PROJECT COMPLETION REPORT

PROJECT NAME: **Timbalier Island Dune/Marsh Restoration Project**
CWPPRA/STATE PROJECT NO. **TE-40**

Report Date: **March 2005** **By:** **Shaw Coastal, Inc.**

SHEET 1 OF 6

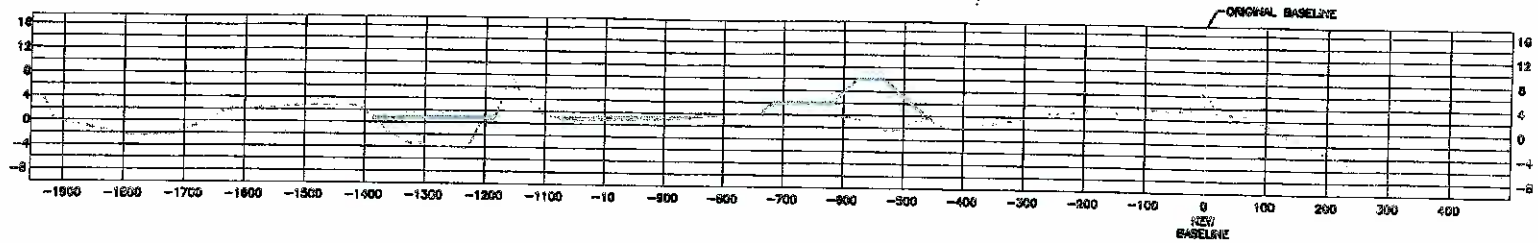
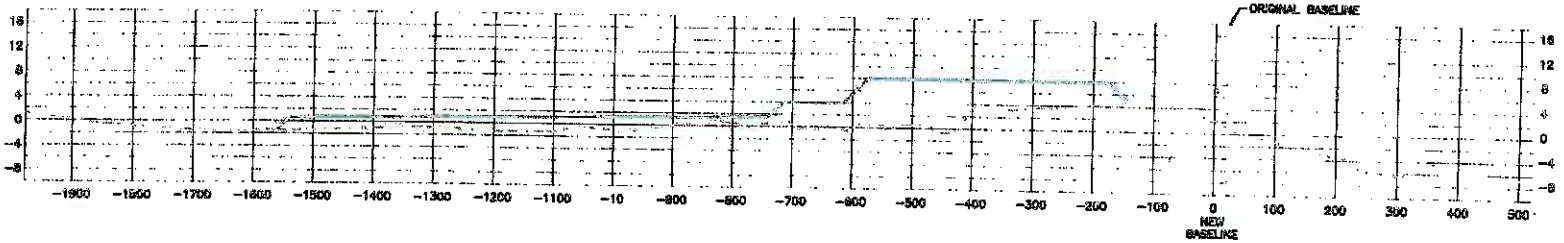
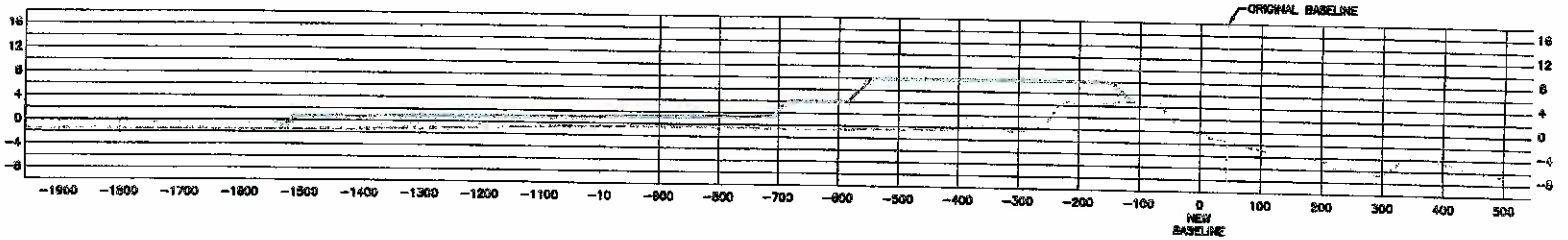
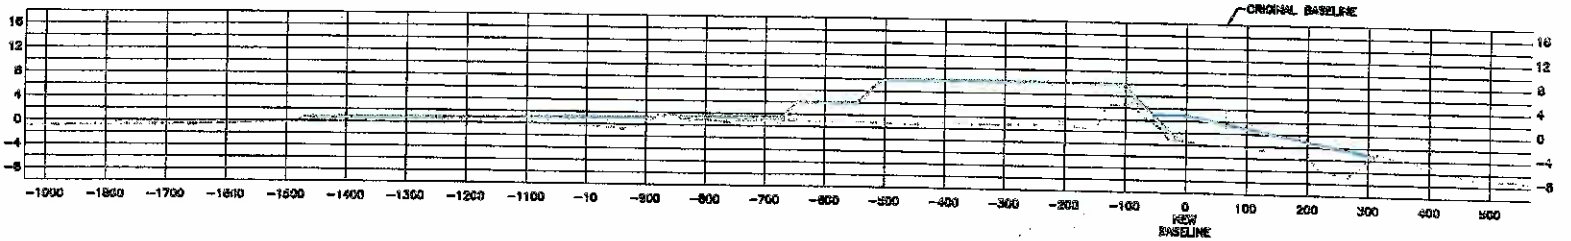
NOTE:
THE GULF SIDE BEACH FILL TEMPLATE AS DEPICTED ON SHEET 6 OF 23 OF THE CONSTRUCTION PLANS HAS BEEN REVISED AS FOLLOWS. THE BERM WIDTH HAS BEEN REDUCED FROM 350' TO ±50'. THE BEACH SLOPE HAS BEEN FLATTEN FROM 30x1 TO 50:1.

SHEET 2 OF 6

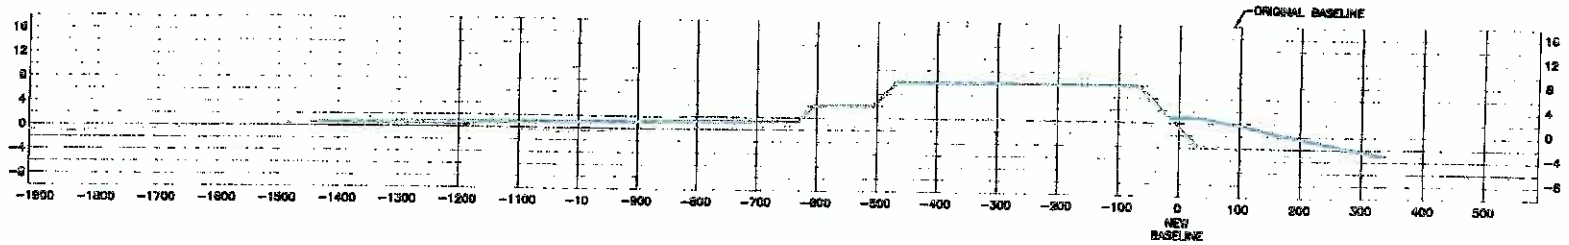
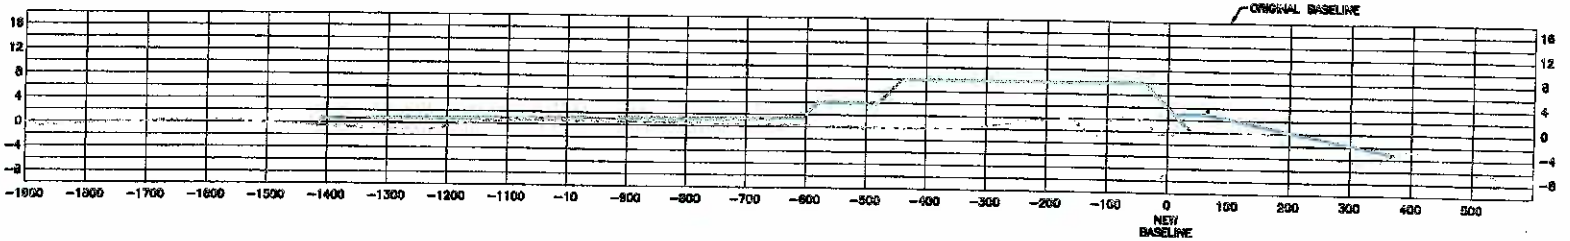
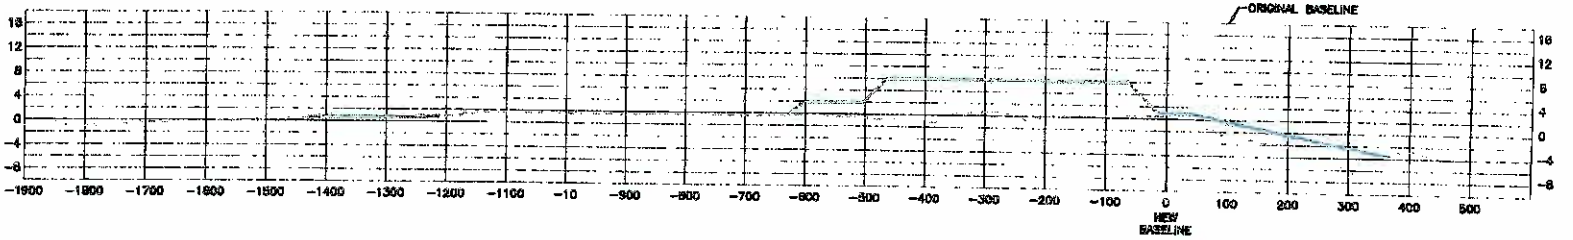
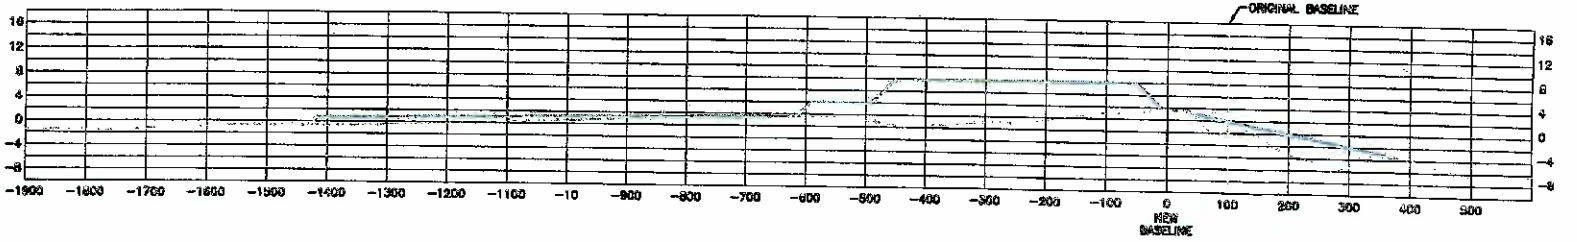
NOTE:
THE GULF SIDE BEACH FILL TEMPLATE AS DEPICTED ON SHEET 6 OF 23 OF THE CONSTRUCTION PLANS HAS BEEN REVISED AS FOLLOWS. THE BERM WIDTH HAS BEEN REDUCED FROM 300' TO ±50'. THE BEACH SLOPE HAS BEEN FLATTEN FROM 30:1 TO 50:1.

SHEET 3 OF 6

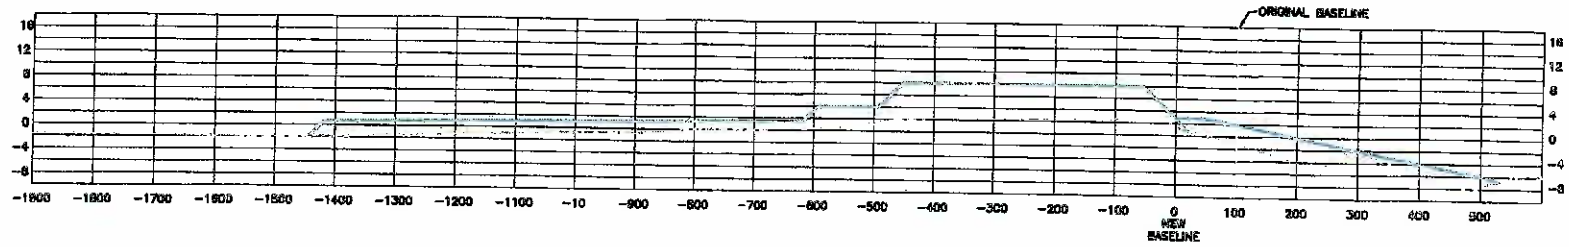
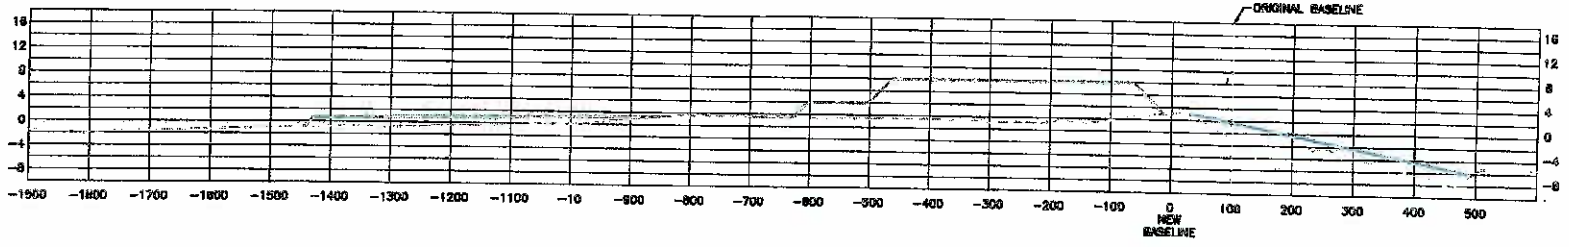
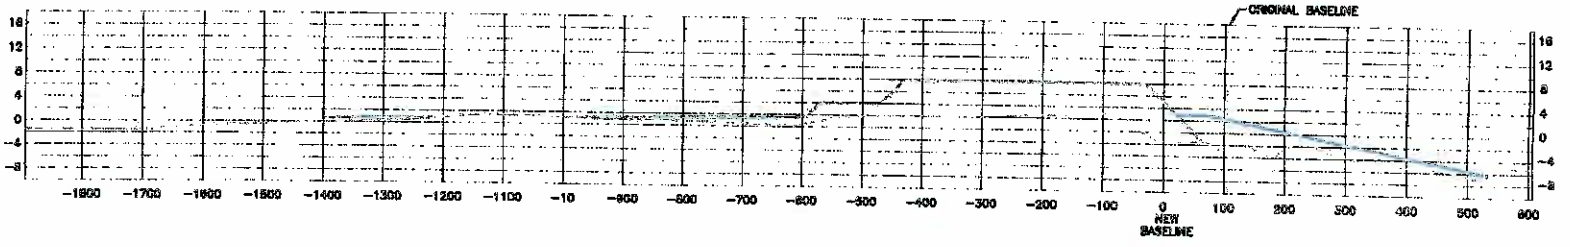
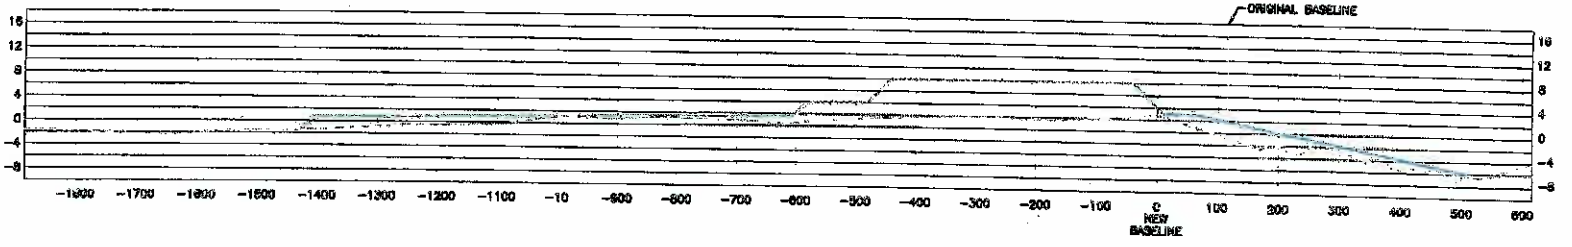
NOTE:
THE GULF SIDE BEACH FILL TEMPLATE AS DEPICTED ON SHEET 6 OF 23 OF THE CONSTRUCTION PLANS HAS BEEN REVISED AS FOLLOWS. THE BERM WIDTH HAS BEEN REDUCED FROM 300' TO ±50'. THE BEACH SLOPE HAS BEEN FLATTEN FROM 30:1 TO 50:1.

DATE: 6/23/01
SHEET 4 OF 6

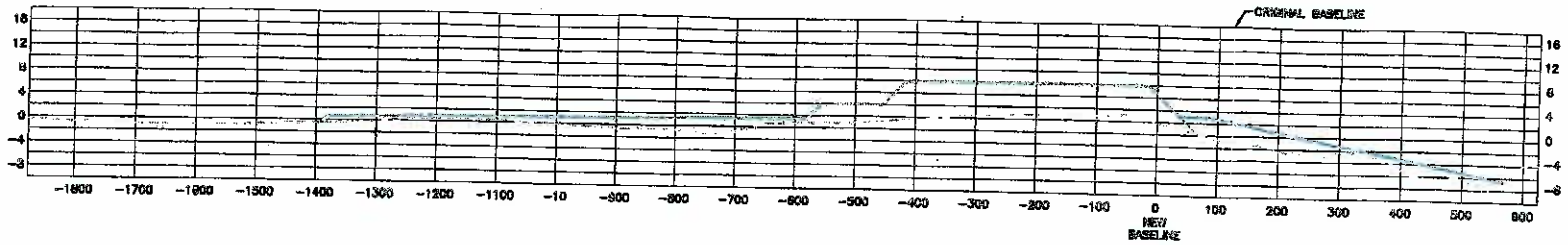
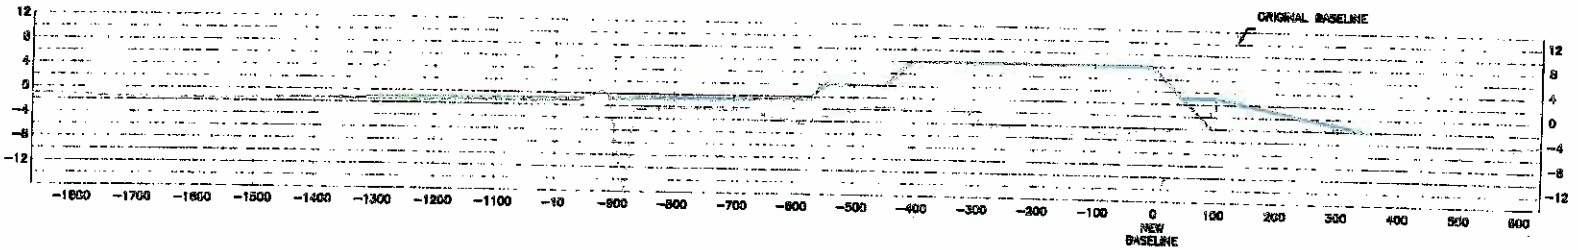
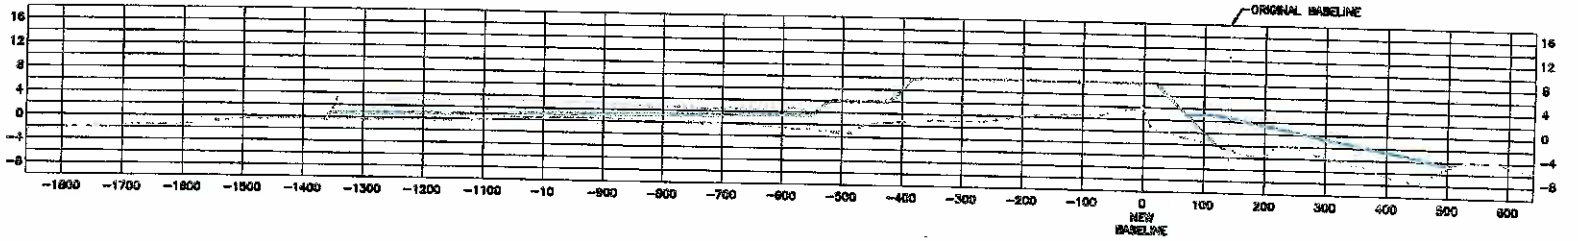
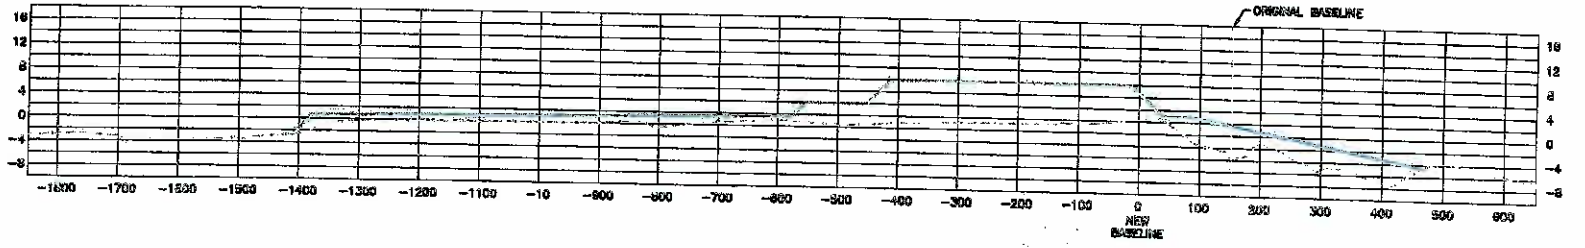
NOTE:
THE GULF SIDE BEACH FILL TEMPLATE AS DEPICTED ON SHEET 6 OF 23 OF THE CONSTRUCTION PLANS HAS BEEN REVISED AS FOLLOWS. THE BERM WIDTH HAS BEEN REDUCED FROM 300' TO ±50'. THE BEACH SLOPE HAS BEEN FLATTEN FROM 30:1 TO 50:1.

DATE: 6/23/04
SHEET 5 OF 6

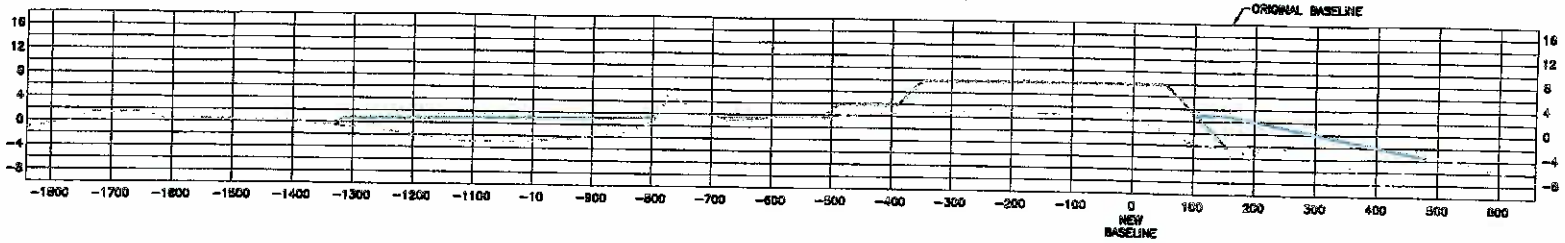
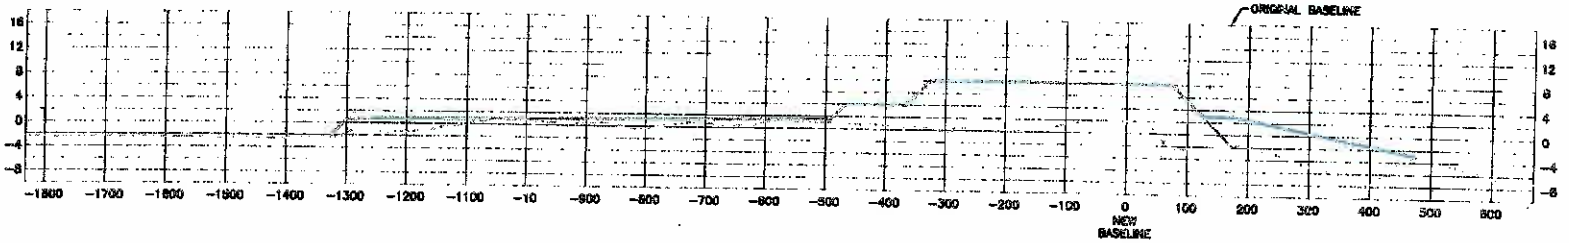
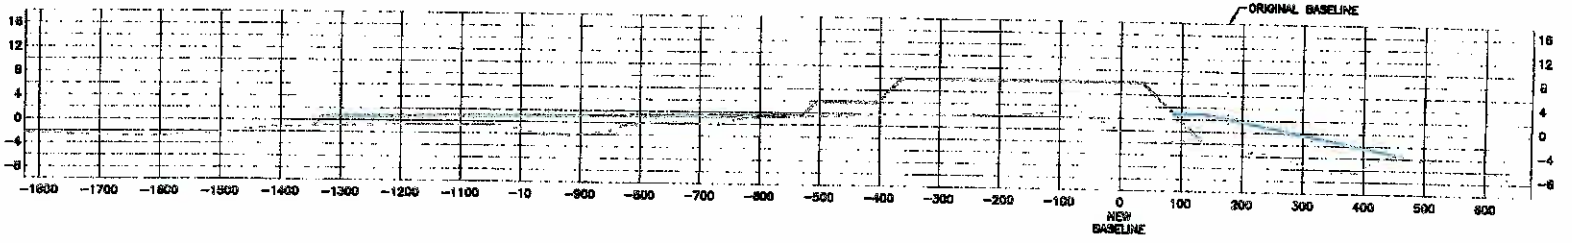
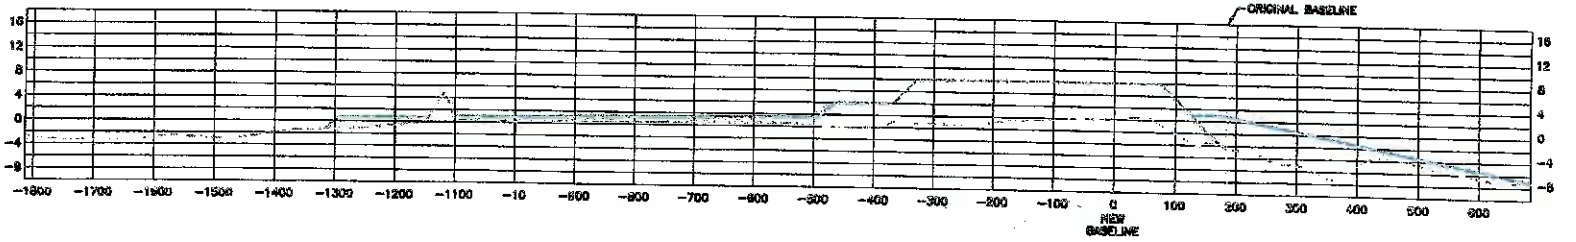
NOTE:
THE GULF SIDE BEACH FILL TEMPLATE AS DEPICTED ON SHEET 8 OF 23 OF THE CONSTRUCTION PLANS HAS BEEN REVISED AS FOLLOWS. THE BERM WIDTH HAS BEEN REDUCED FROM 300' TO ±30'. THE BEACH SLOPE HAS BEEN FLATTEN FROM 30:1 TO 50:1.

SHEET 6 OF 6

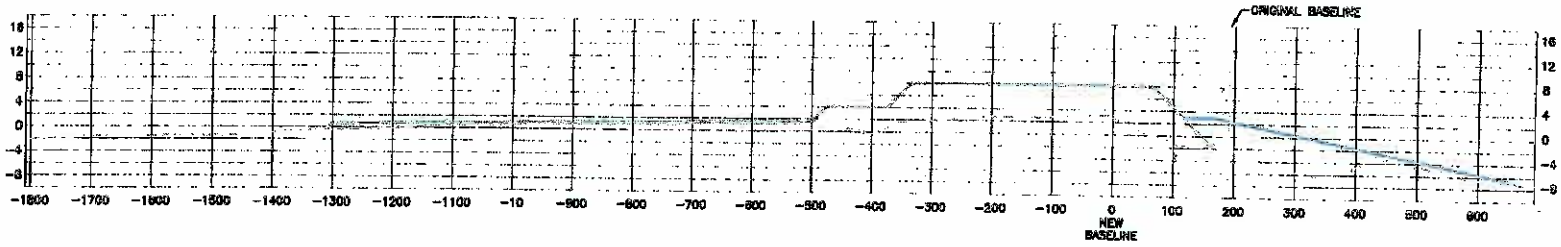
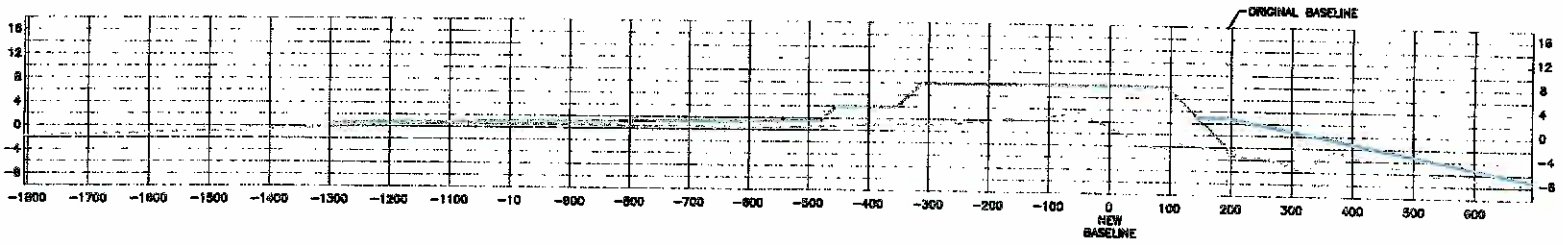
NOTE:
THE GULF SIDE BEACH FILL TEMPLATE AS DEPICTED ON SHEET 9 OF 23 OF THE CONSTRUCTION PLANS HAS BEEN REVISED AS FOLLOWS. THE BERM WIDTH HAS BEEN REDUCED FROM 300' TO ±90'. THE BEACH SLOPE HAS BEEN FLATTEN FROM 30:1 TO 50:1.
